Revision of Manuscript Number: IEEE-TPWRS-01391-2021, version 1 January 1, 2022
Journal: IEEE Transactions on Power Systems
Author: Abhishek Halder, Kenneth F. Caluya, Pegah Ojaghi, Xinbo Geng

Response to decision:

Response to AE:

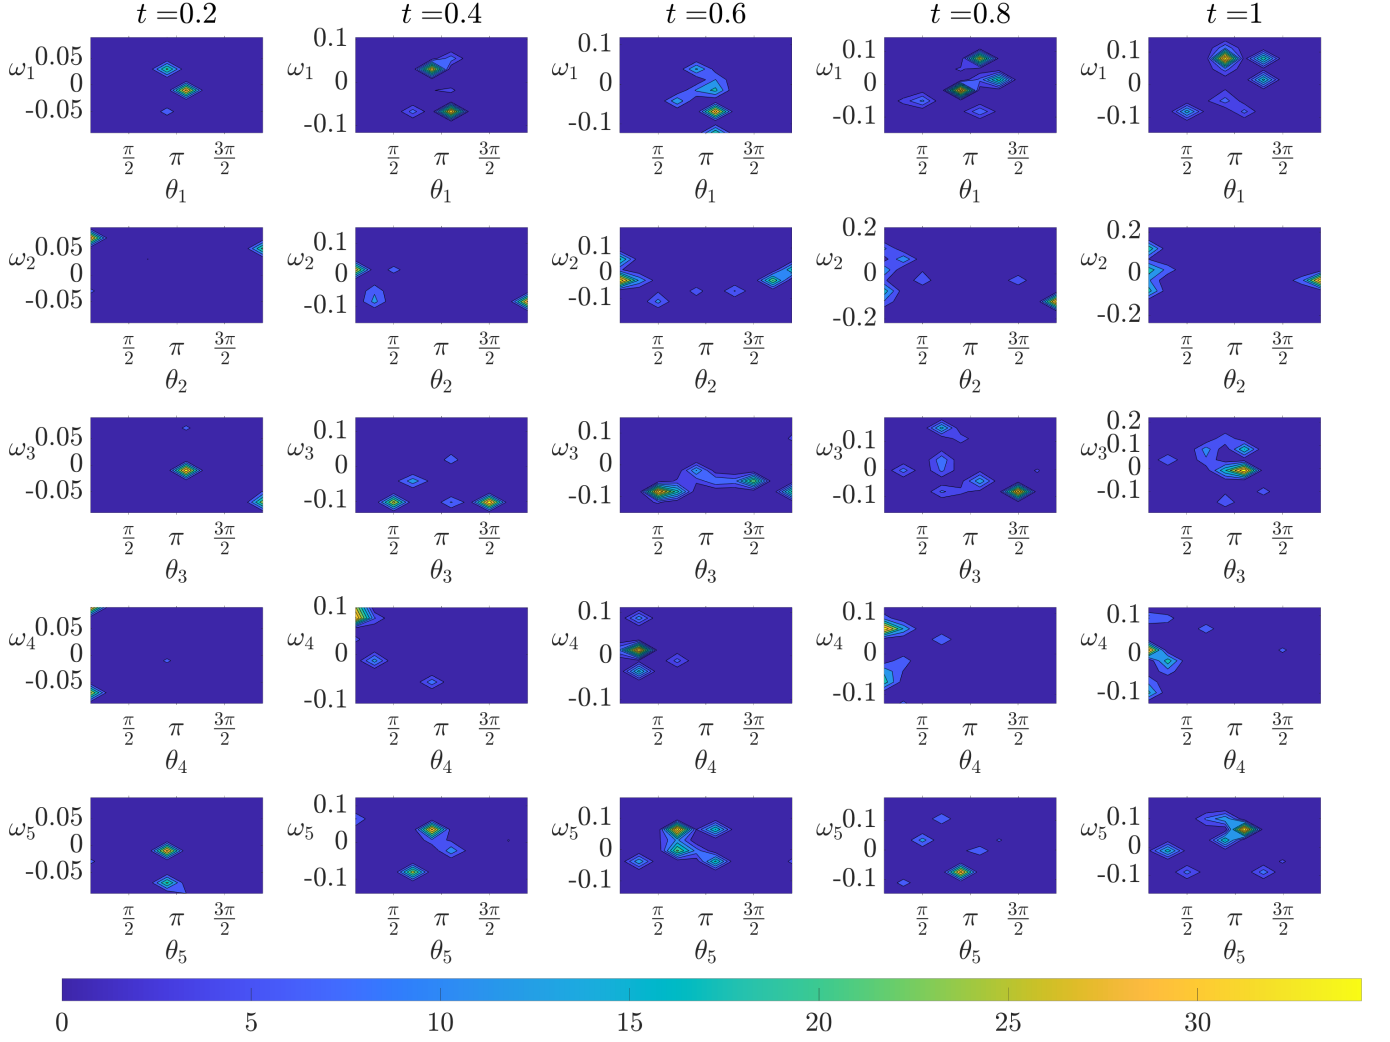
Figures 5 and 6 are unreadable.

Response: Thanks for this comment. In the previous version, the strict 10 page limit enforced small figure sizes. In the revised manuscript, Figures 5 and 6 are made larger. Also, the Fig. 6 in the revised manuscript shows the transient (θ_i, ω_i) bivariate marginals for all the five generators in Case II; the previous version showed the same only for the generator 4 (bus 6). We believe these changes have improved clarity.

Regarding the style of plots, we had considered plotting the bivariate marginals as planar contour plots (as in Fig. 1 in this rebuttal document) but decided against it because of the following two reasons.

First, in our opinion, this kind of plot is scientifically misleading as they hide the fact that these bivariate marginal PDFs are not really supported on the plane, or the subsets thereof, but instead have cylindrical supports. Our message that the proposed method explicitly accounts this manifold geometry in the computation, would be missed had we chosen to make the plots as per populist cognitive bias on behalf of the readers. That the planar plots evoke a sense of familiarity cannot be a scientific argument in favor of it.

Second, the planar contour marginal plots require additional mental efforts from the readers to correctly parse the statistical information conveyed. For instance, consider the fourth column, second row subplot in Fig. 1 in this rebuttal document. It is upon the reader to parse that the two high probability regions on the left and right of that subplot are actually referring to the same angular high probability region around $\theta_2 = 0$, thanks to the periodic boundary condition on the angular variable. Our philosophy of technical communication is that the onus is on the authors, not on the readers, to clarify the scientific information as correctly as possible. And yes, we are aware that many papers in the power system literature make plots in the rectangular domain ignoring the manifold nature of the support, which in our experience, continue

to add pain to the graduate students and beginning researchers trying to understand the statistical meaning conveyed in those plots. We prefer ours not be contributing to the accrual of such pain, and instead make plots that depict the variables as they are.
